Transmittal Number PT 12-036	Date April 2012
Publication Title / Publication Number <i>Geotechnical Design Manual M 46-03.07</i>	
Originating Organization Environmental and Engineering Programs, Geographical Services

# **Geotechnical Design Manual**

M 46-03.07

# STANDARD ARES PRECAST PANEL RETAINING WALL DETAILS

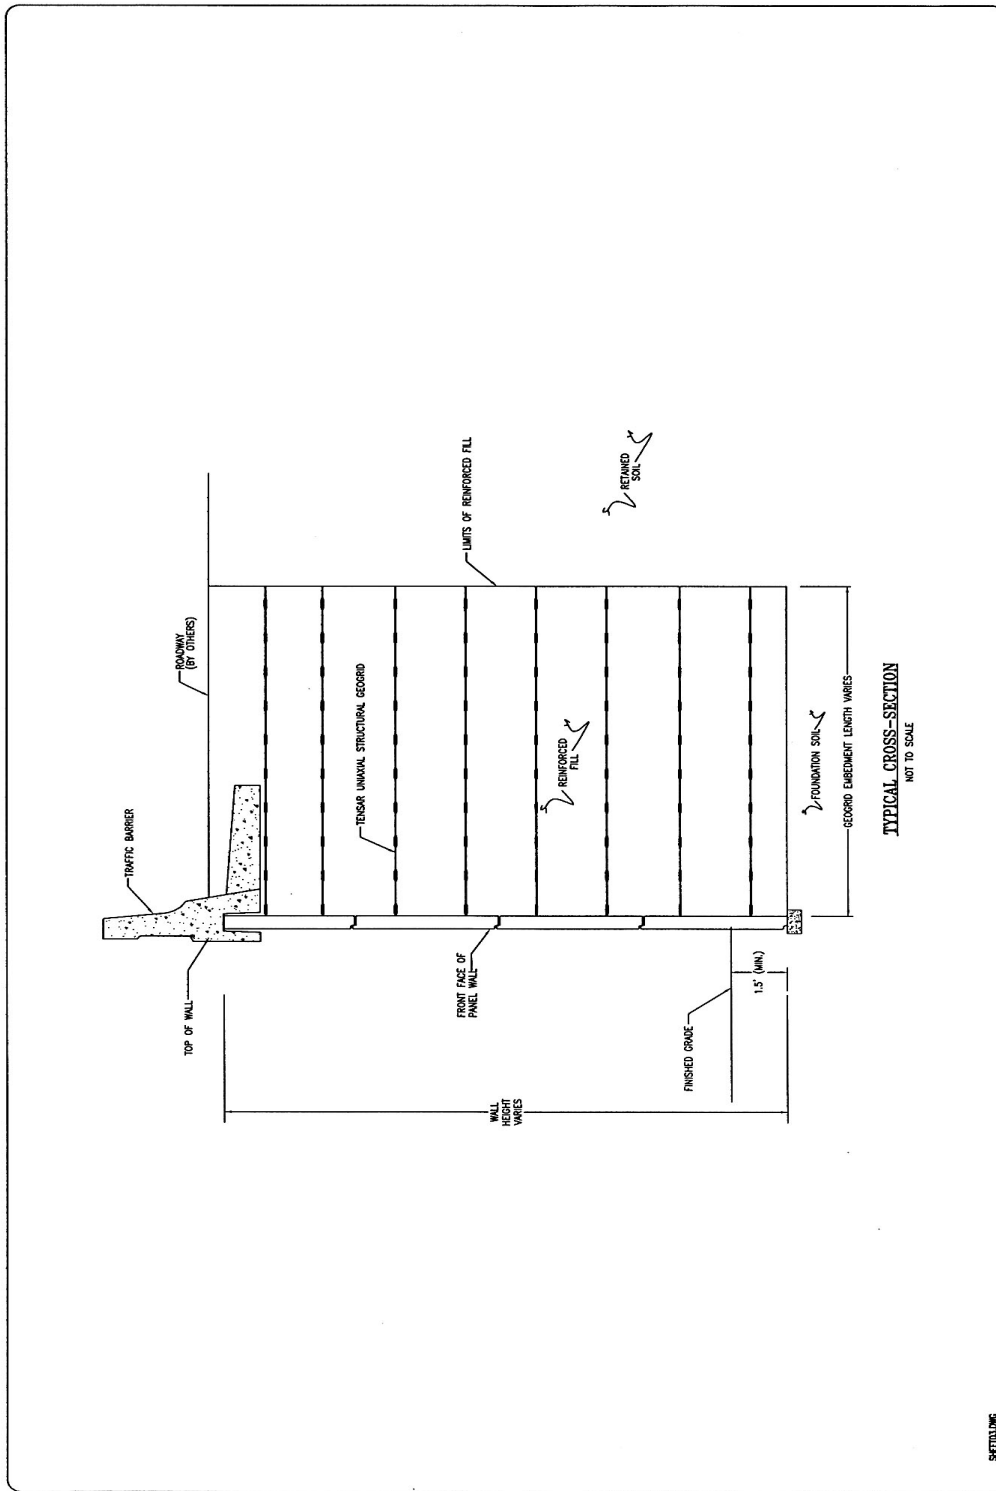
- In plan sheet 3 of 19, there should be a minimum cover of 4 inches of soil between the geogrid and the traffic barrier reaction slab.
- In plan sheet 8 of 19, the strength of the geogrid and connection available shall be reduced by 10% to account for the skew of the geogrid reinforcement. The skew angle relative to the perpendicular from the wall face shall be no more than 10°.

STANDARD ARES PRECAST PANEL RETAINING WALL DETAILS	
ARES ARTICULATED PANEL LEVELING PAD	Sheet Number 10 of 19

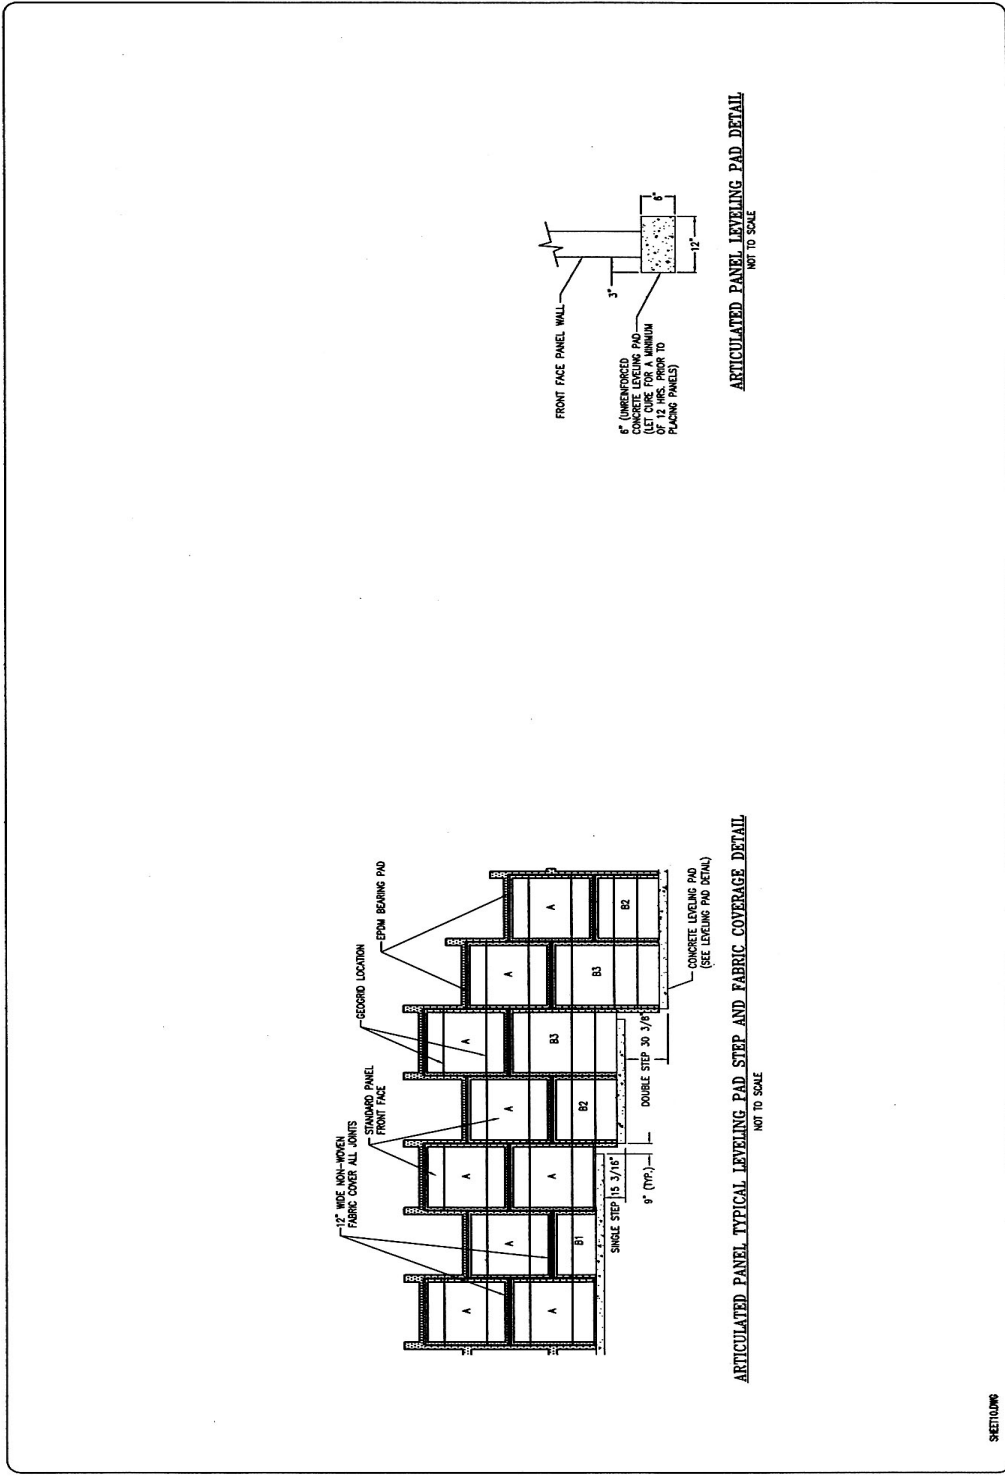
- In plan sheets 10 and 14 of 19, regarding the filter fabric shown, WSDOT reserves the right to require the use WSDOT Standard Specification materials as specified in Standard Specification Section 9-33 that are similar to those specified in this plan sheet.

STANDARD ARES PRECAST PANEL RETAINING WALL DETAILS	
TYPICAL DETAILS	Sheet Number 15 of 19

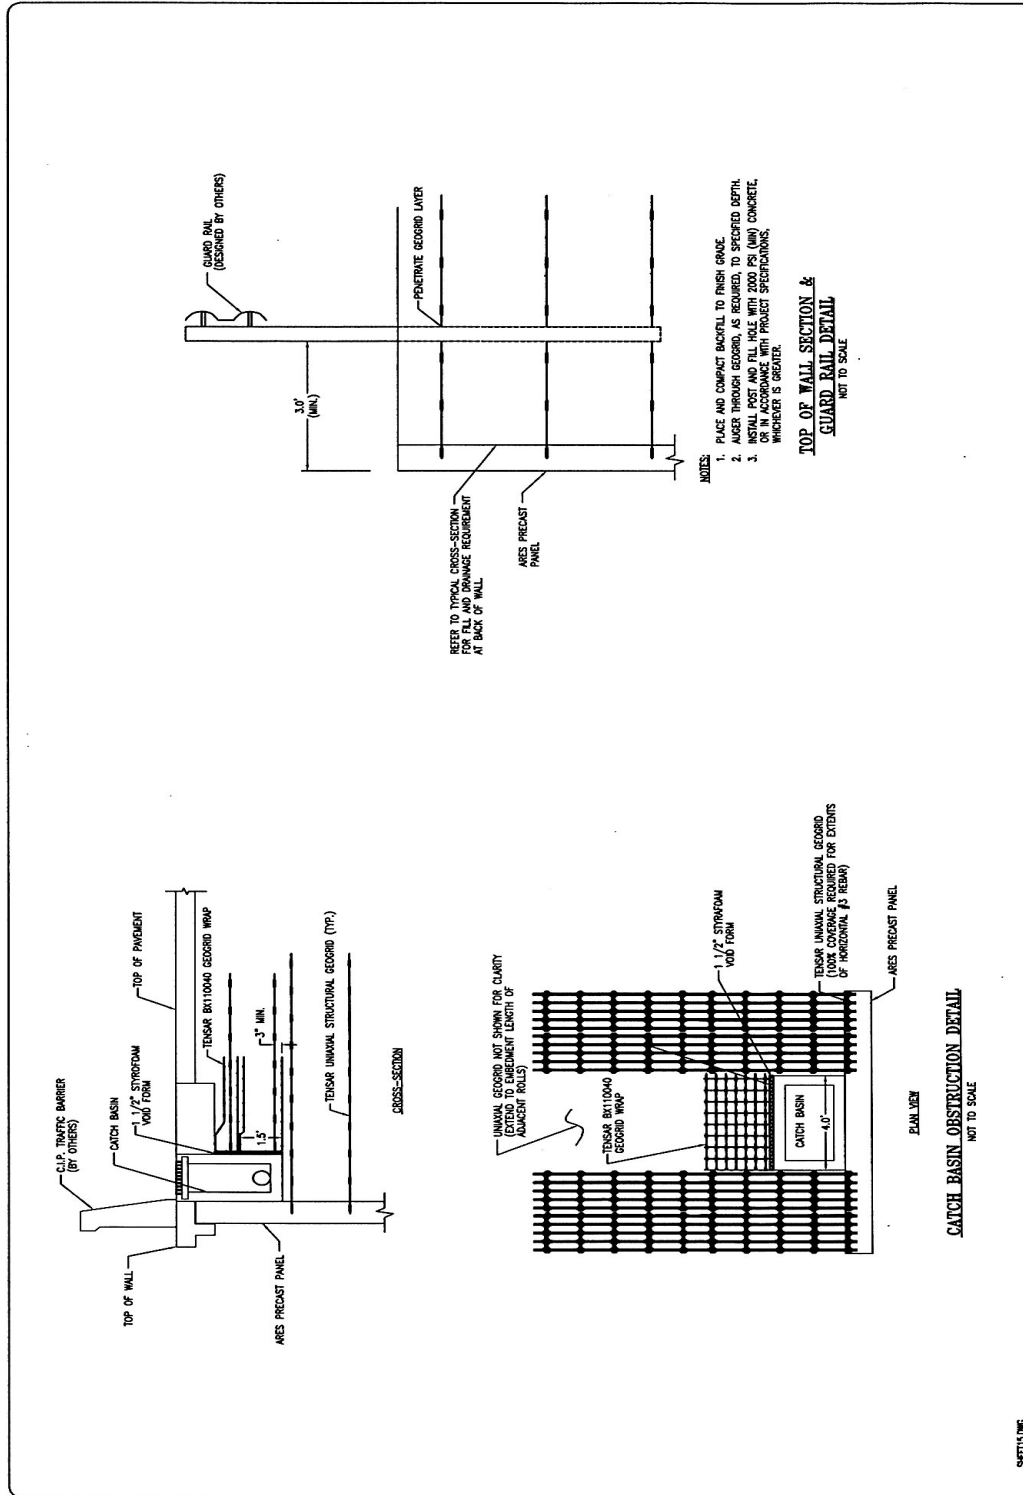
- In plan sheet 15 of 19, the guard rail detail, the guard rail post shall either be installed through precut holes in the geogrid layers that must be penetrated, or the geogrid layers shall be cut in a manner that prevents ripping or tearing of the geogrid.

**BODKIN CONNECTION**

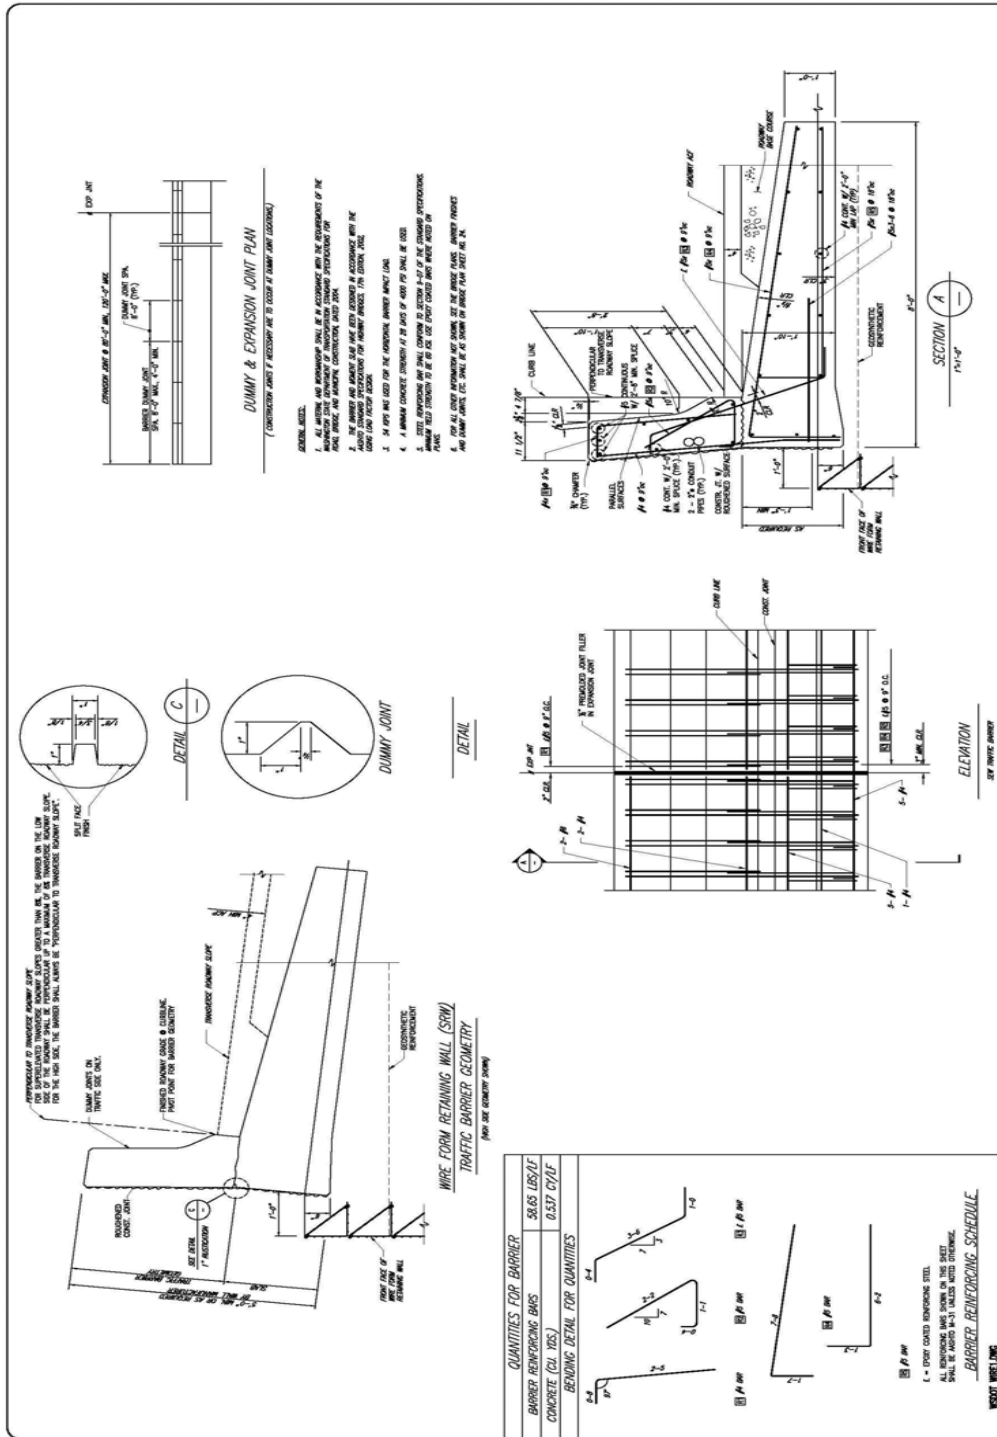
- No more than one Bodkin connection may be used within any given layer, and on no more than 50% of the layers in a given section of wall.
- If the Bodkin connection is located outside of the active zone for the wall as defined in the AASHTO LRFD Bridge Design Specifications plus 3 ft and is located at least 4 ft from the face, no reduction in design tensile strength due to the presence of the Bodkin connection is required.

- If the Bodkin connection is located closer to the wall face than as described immediately above, the design tensile strength of the reinforcement shall be reduced to account for the Bodkin connection. Table 15-(Tensar WW)-1 provides a summary of the reduction factors to be applied to account for the presence of the Bodkin connection.
